ADDENDUM NO4Date: **April 10, 2026**Project No.: **2596**Project: **Alderville Senior's Residence
Renovations**

ADDENDUM FP01

26-1580 – Alderville Seniors Residence Renovation

Date: April 09, 2026
 Project: Alderville Seniors Residence Renovation
 Project No: 25-088
 No: ADD-ME04

FIRE PUMP DETAIL - SECTION A

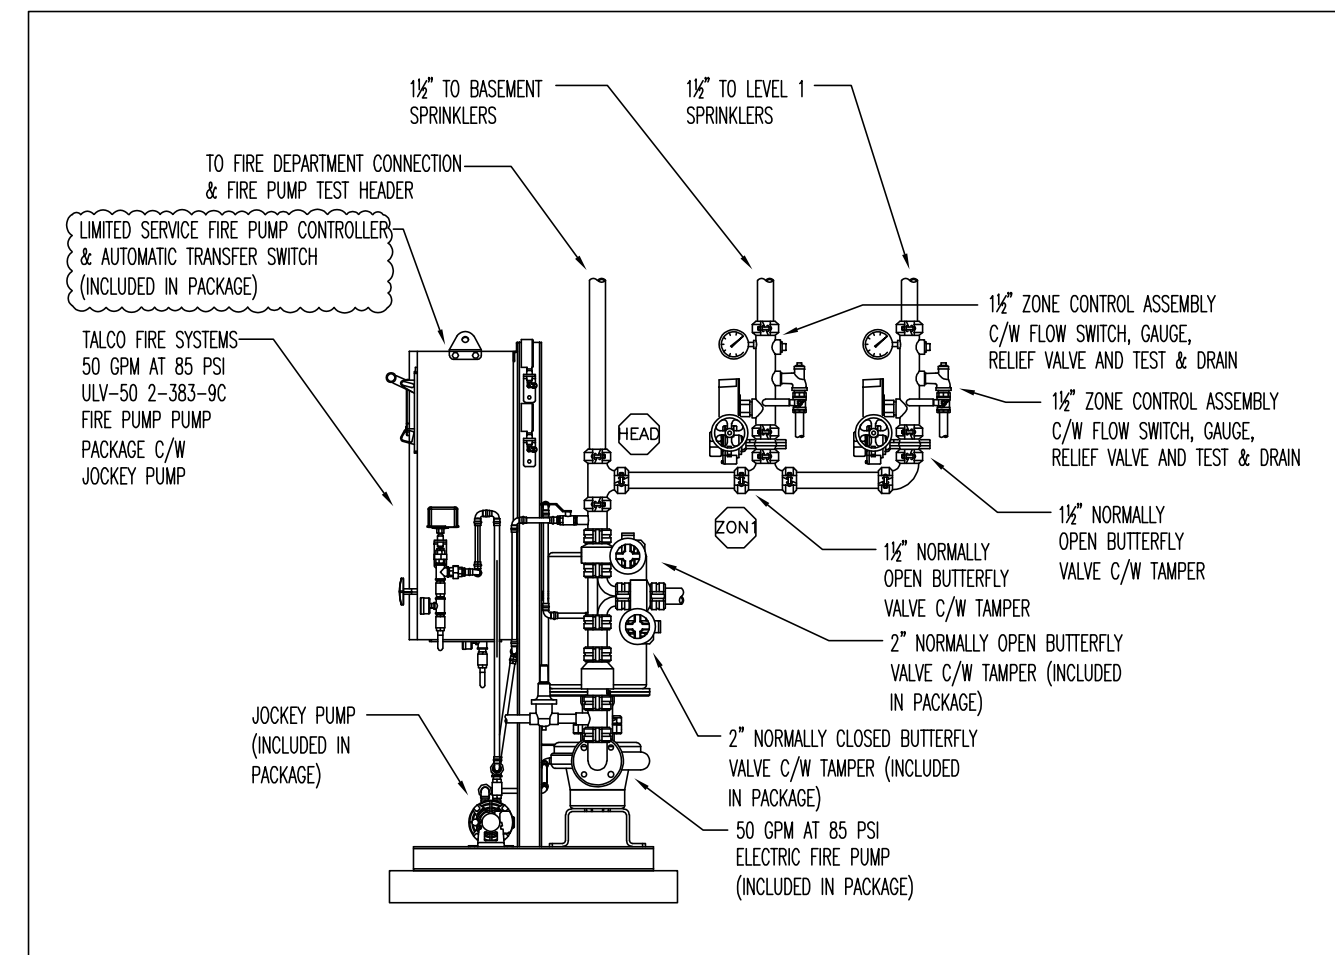
- .2 *On drawing FP1 General Notes #5 the fire pump is to be connected to emergency power supplied by others. Are we to allow for a transfer switch for the pump controller or is the transfer switch being supplied by the electrical contractor?*

- .1 The note regarding the fire pump controller has been updated to include the automatic transfer switch in Fire Pump Detail – Section A and Fire Pump Detail – Section B.

The fire protection contractor is to supply a fire pump controller that includes the optional automatic transfer switch.

3 REGARDING UPDATING LEGEND

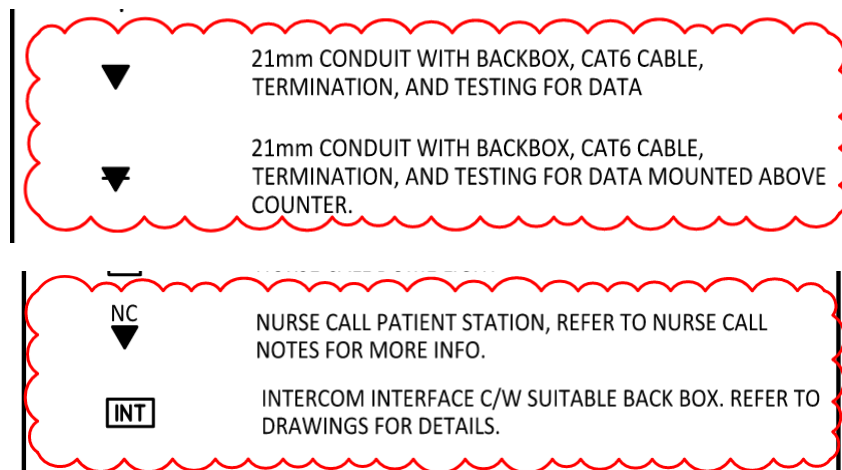
- .1 Refer to the legend clarifications below. The data cabling is to be included in the contract and terminated in the mechanical room. The Nurse call and Intercom are also clarified.
